AICROCHIP PIC18F8720/8620/6720/6620

PIC18F8720/8620/6720/6620 Rev. A4 Silicon/Data Sheet Errata

The PIC18F8720/8620/6720/6620 parts you have received conform functionally to the Device Data Sheet (DS39609**B**), except for the anomalies described below.

FIGURE 26-3: PIC18F6620/6720/8620/8720 VOLTAGE-FREQUENCY GRAPH (INDUSTRIAL, EXTENDED)

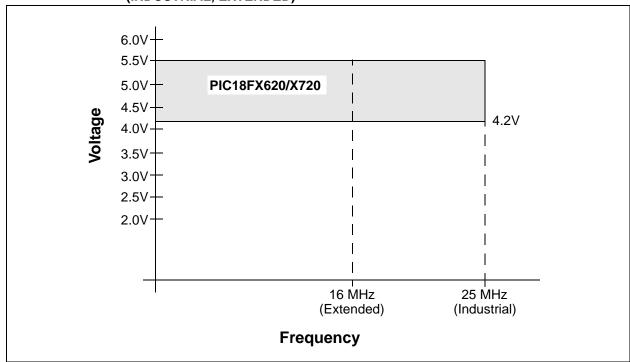
1. Module: Voltage-Frequency Graph

In Section 26.0 "Electrical Characteristics", the following figure has been updated to clarify the voltage frequency for Extended devices.

FIGURE 11-1: TIMERO BLOCK DIAGRAM IN 8-BIT MODE

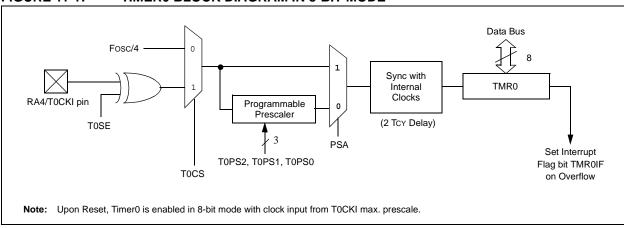
10. Module: Timer0 Block Diagram in 8-Bit and 16-Bit Modes

The PSA multiplexor bit values in Figures 11-1 and 11-2 do not match the text description of the Timer0 PSA bit in the T0CON register.

The bit values have been corrected by swapping the values as shown below (correct values are shown in **bold** text):
